**PLEASANT PRAIRIE PLAN COMMISSION MEETING
VILLAGE HALL AUDITORIUM
9915 39th AVENUE
PLEASANT PRAIRIE, WISCONSIN
6:00 P.M.
APRIL 14, 2014**

Consider the request of Mark Molinaro, Jr. of Partners In Design Architects, agent on behalf of the Hospice Alliance Foundation, Inc. for approval of **Site and Operational Plans** to expand the parking for their facility located at 10220 Prairie Ridge Blvd.

HOSPICE ALLIANCE PARKING LOT EXPANSION
 Pleasant Prairie, Wisconsin
Architectural Site Plan

SHEET NUMBER:
C-2.0

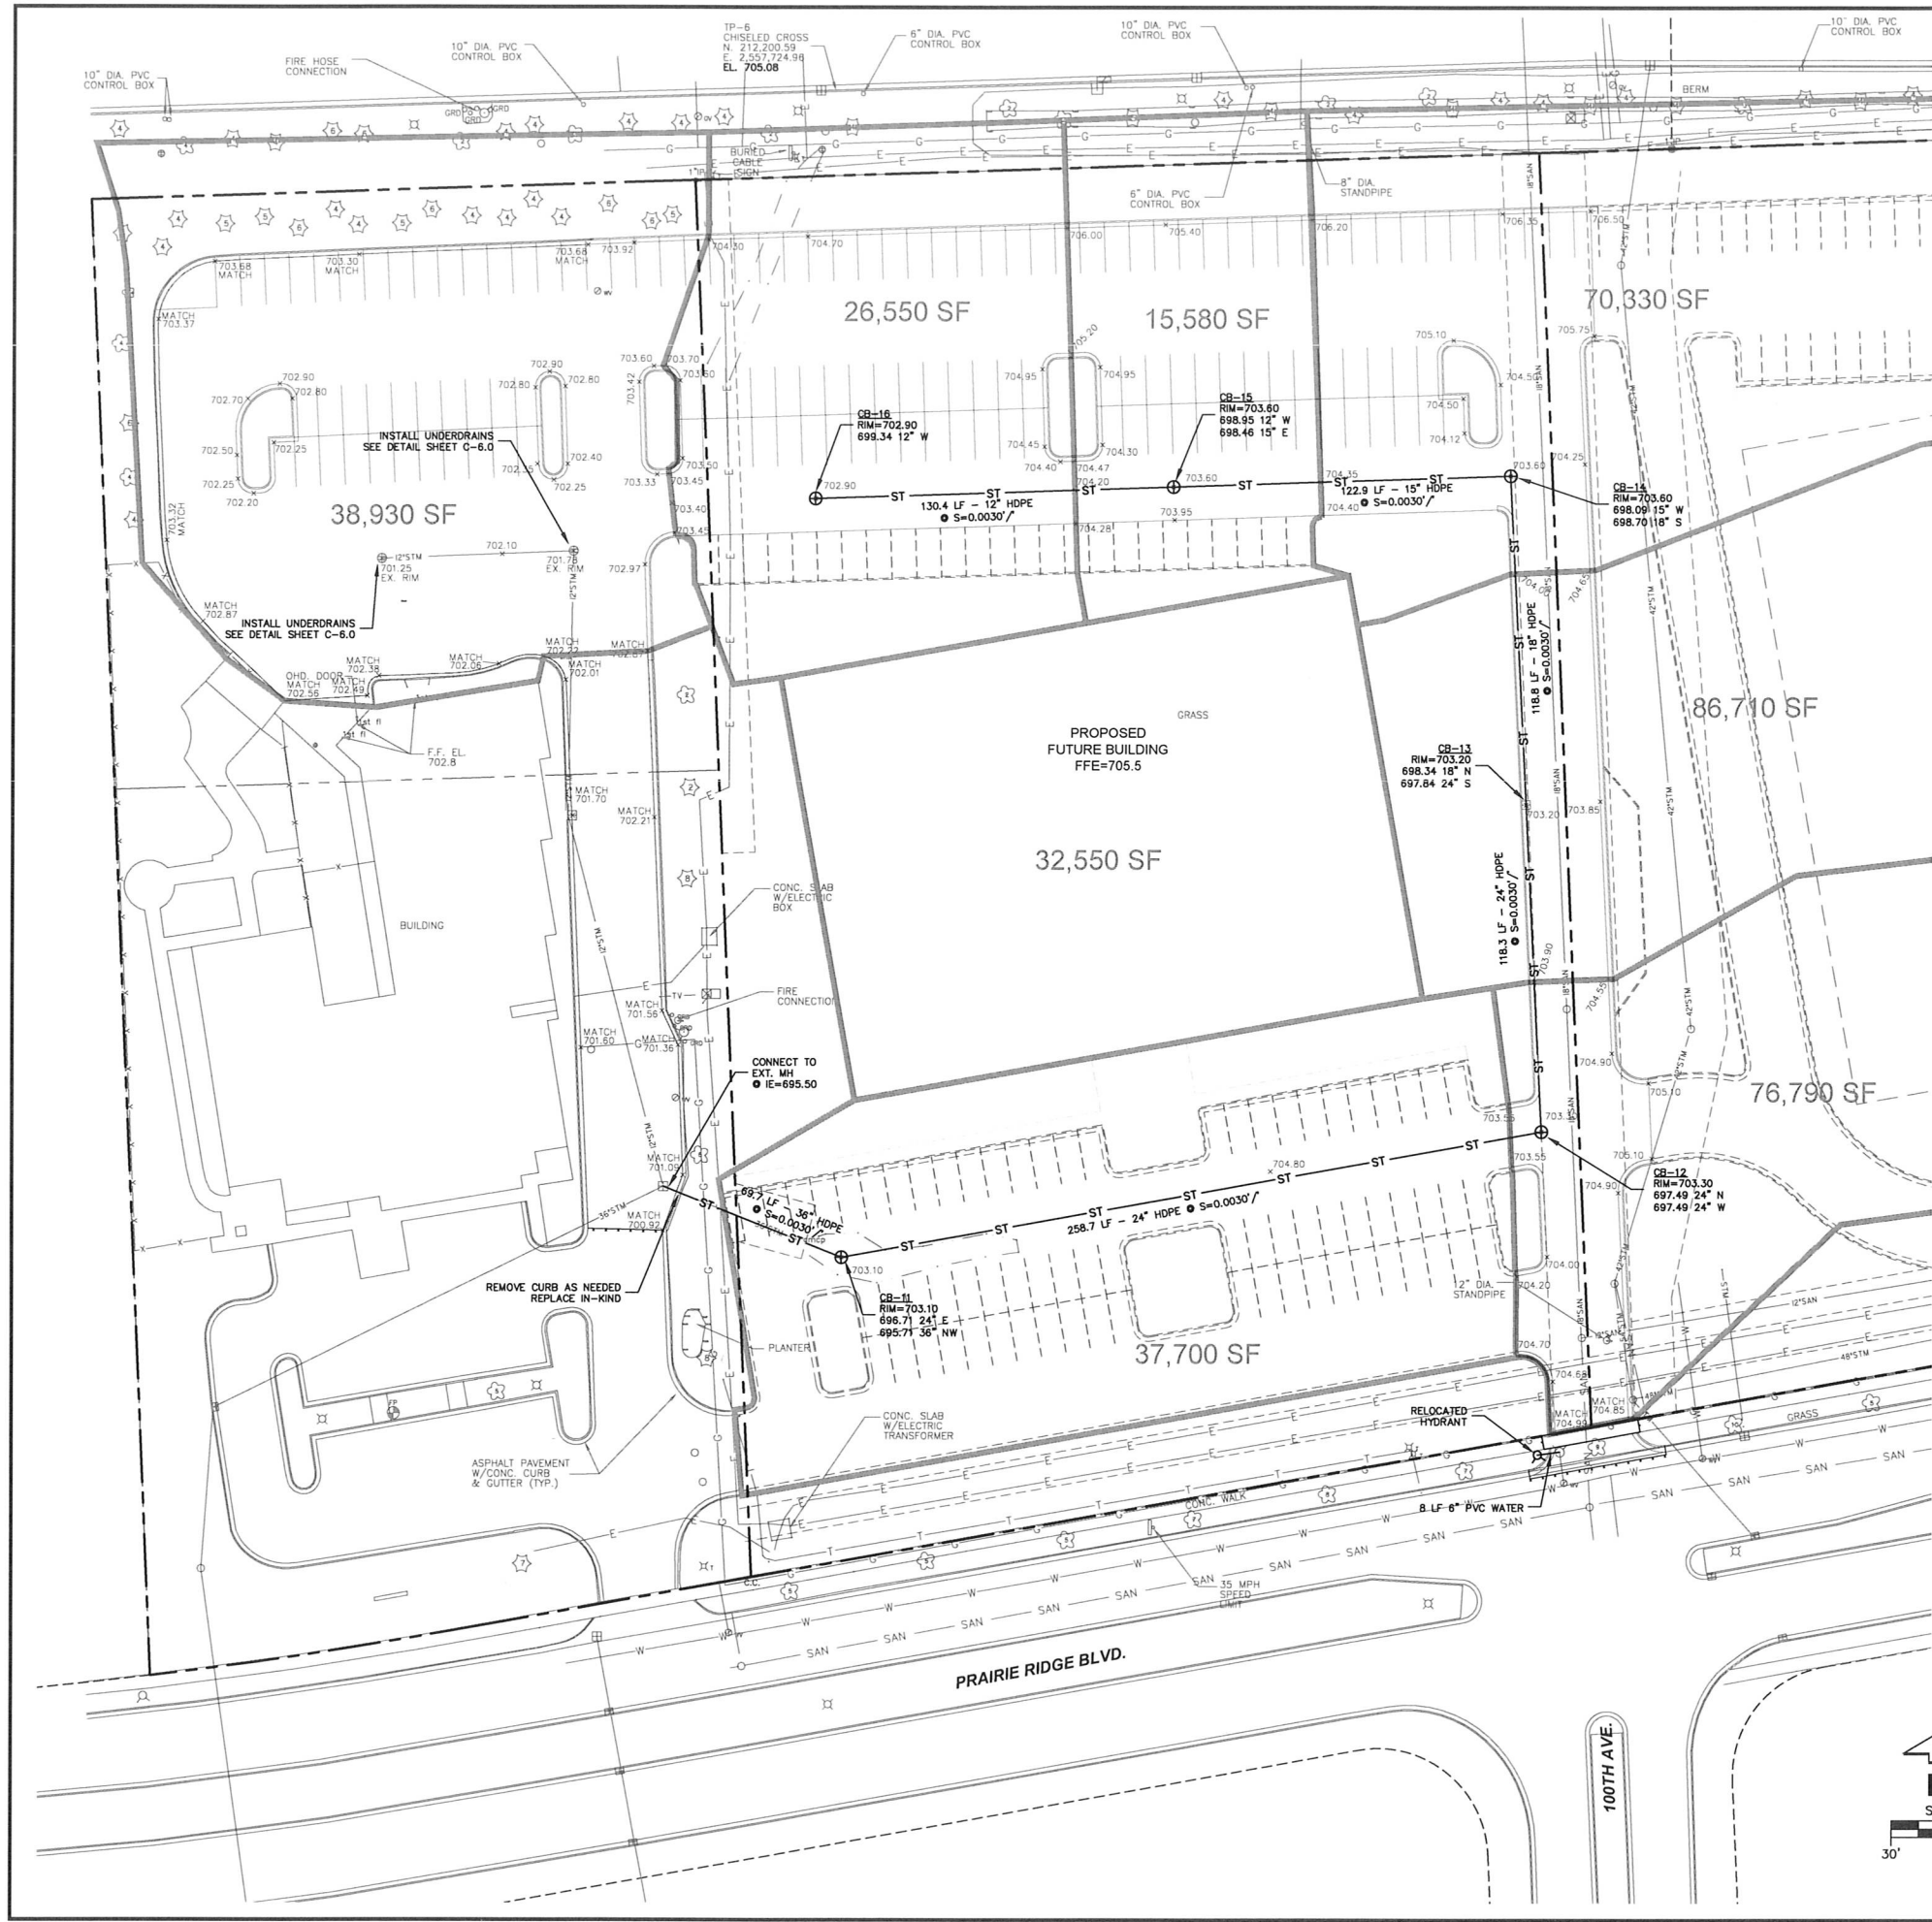
- j. **Site Grading & Erosion Control Plan**
 - i. Check and correct the contour elevation label around CB -13. It is currently labeled as 703 (supposed to be 704?).

- ii. Adjust the plan as needed to provide positive drainage north of new parking lot within the green space. Currently the curb grades show that drainage will be trapped.

- iii. Adjust the plan as needed to provide positive drainage by the new east access road, west side between the curb and the 704 contour. As shown it appears the drainage will be trapped behind the curb.

SHEET NUMBER:
C-3.0

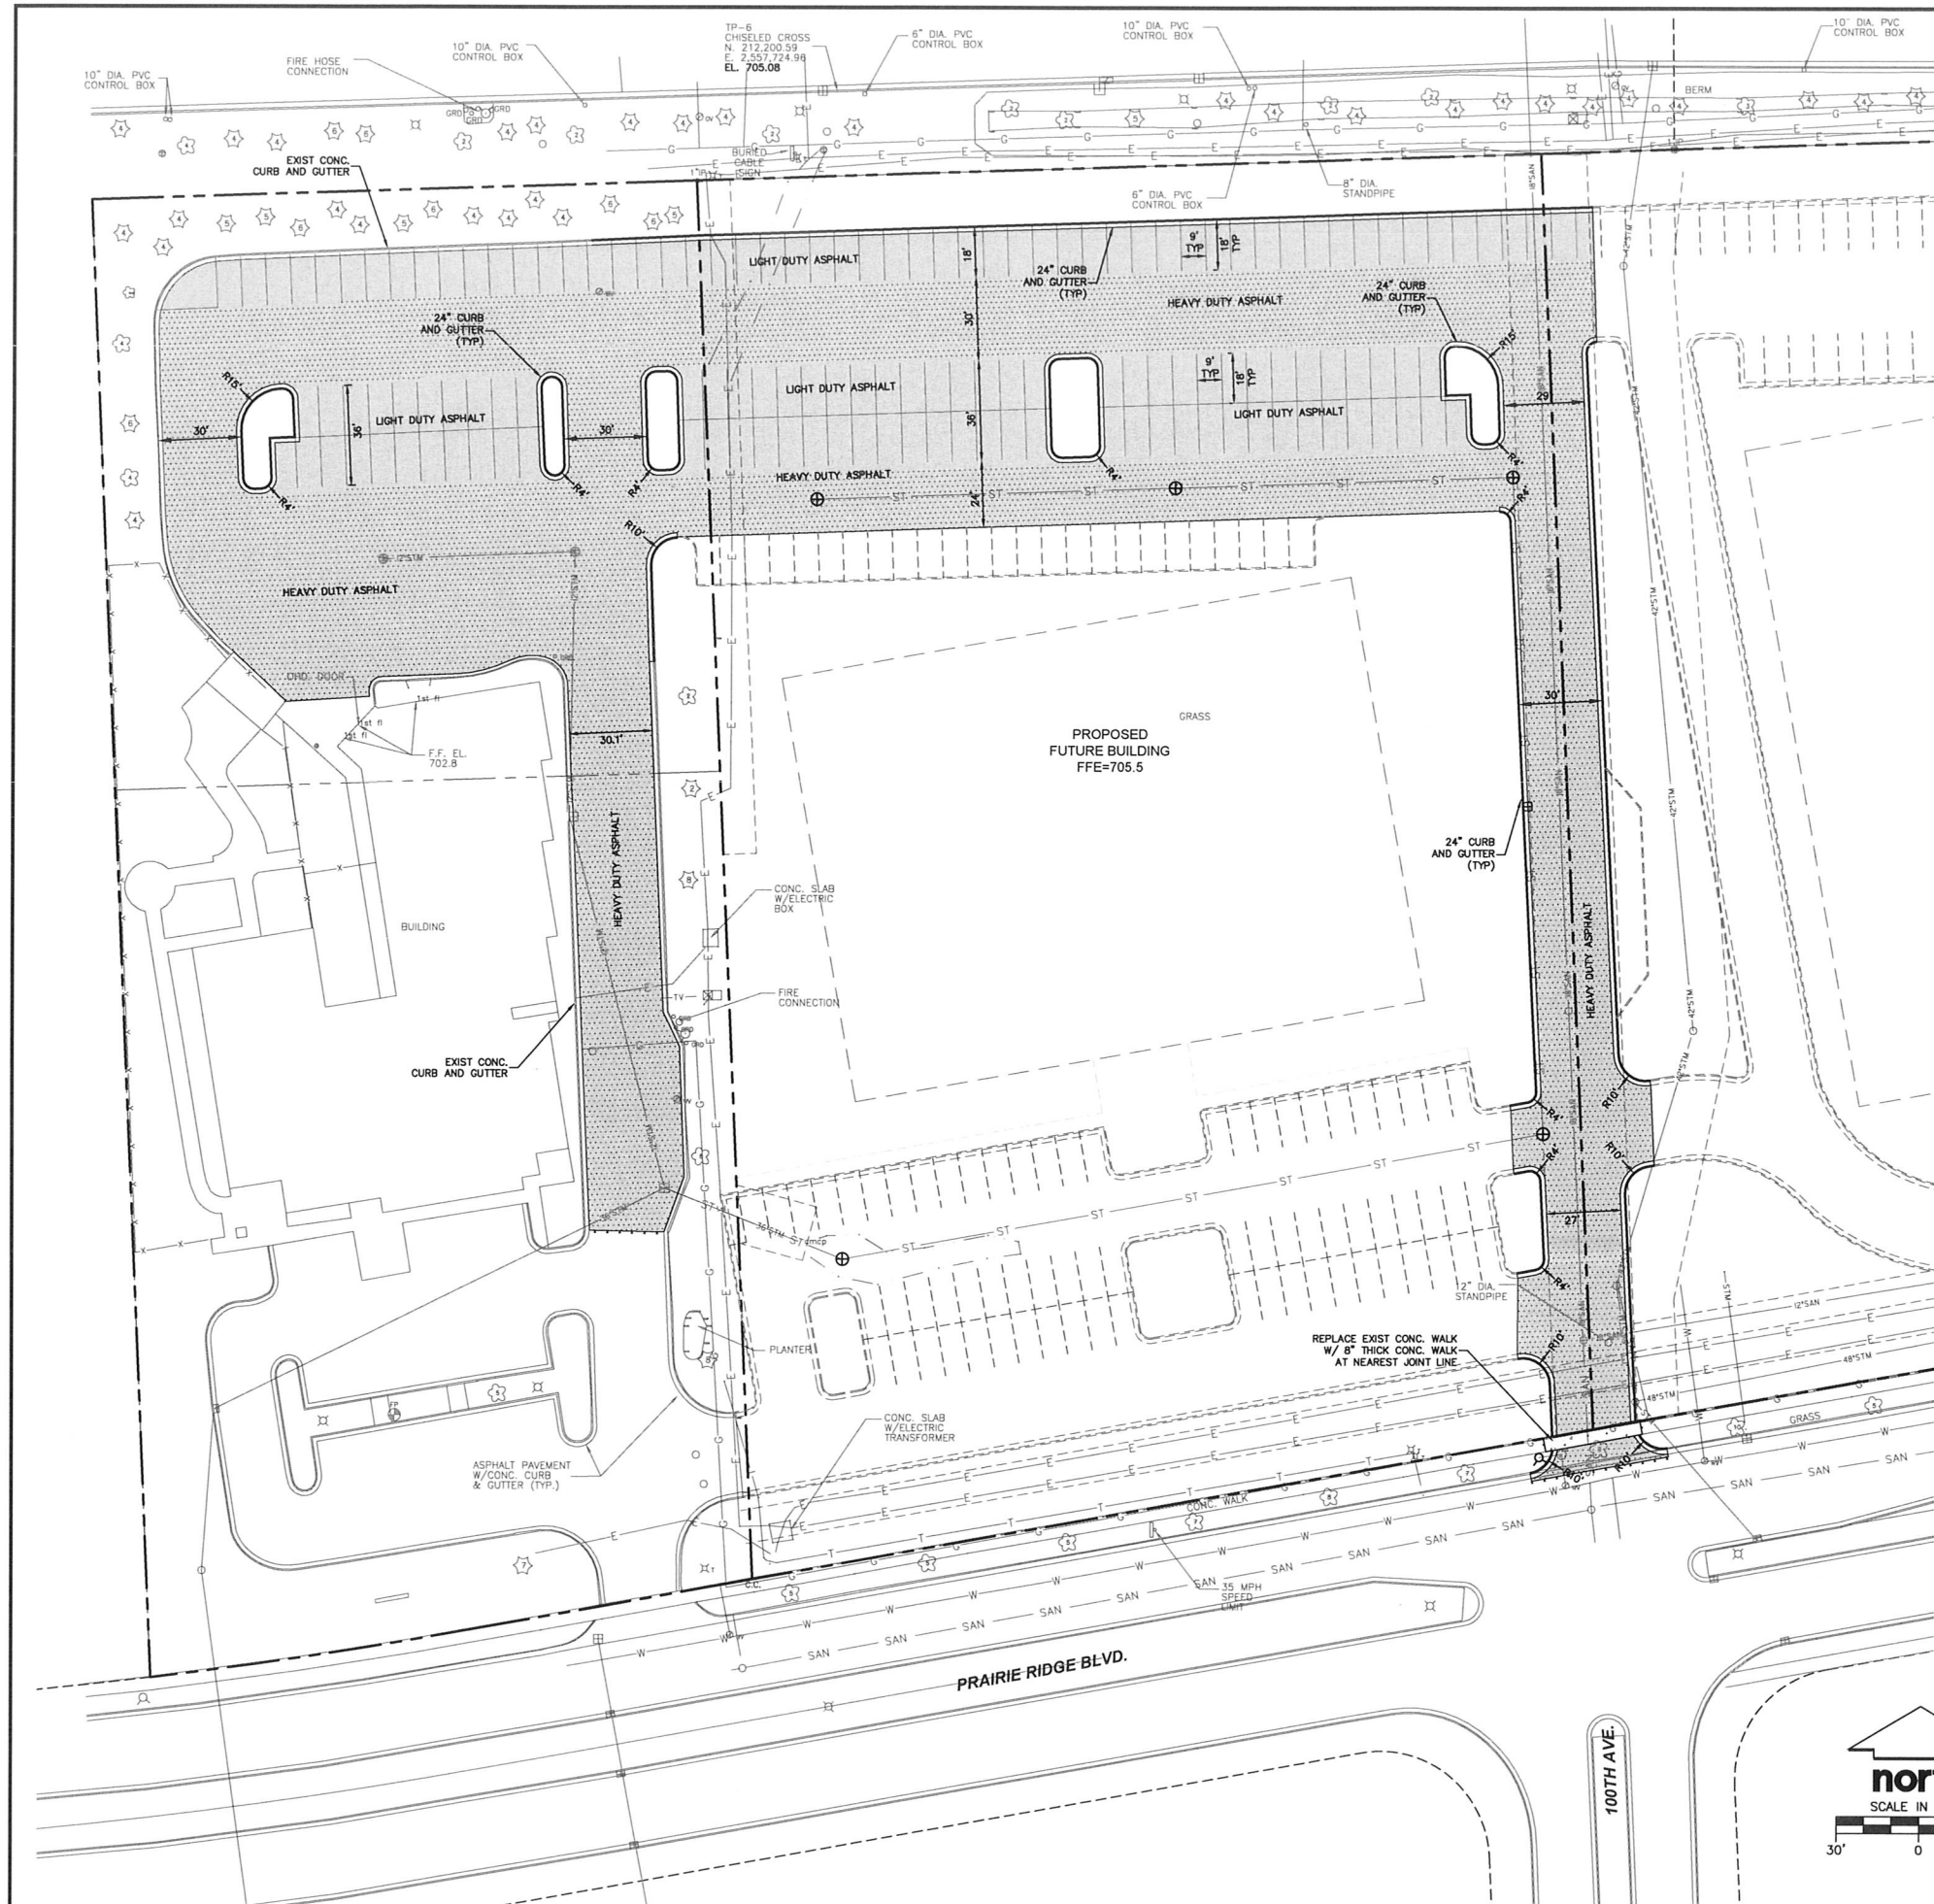
- k. **Site Utility Plan**
 - i. Show leader notes for existing sanitary and storm manhole adjustments. Adjustment shall be to Village specifications. A copy of Village specifications for manhole adjustments is ***attached***.

- ii. Show the correct storm manhole detail (see ***attached***).
 - iii. Further investigation is needed regarding what the existing 12-inch stand pipe is and what is being done with it or proper abandonment specifications etc. (Is this an old well?)

- iv. Eliminate the reference to the Racine Water utility in utility note number 4.
 - v. The lead for the hydrant relocation shall be Ductile Iron (Class 53). The plans shall be corrected accordingly.

- vi. Provide a copy of the storm sewer calculations. Identify what pipes are sized for future roof drainage. Also, the existing offsite drainage from the east shall be included in the pipe sizing calculations or addressed.

- viii. The plans show an existing storm manhole within the new curb line by the entrance near the sidewalk. This situation needs to be addressed. The manhole casting / cover shall not be in the curb.

- ix. Place a note on the plans stating that all work on Village owned public infrastructure (hydrant relocation, manhole adjustments, sidewalk, curb and gutter etc.) shall inspected by the Engineering Department. Contractor shall coordinate and schedule inspections with the Engineering Department (262-948-8951) prior to performing work.
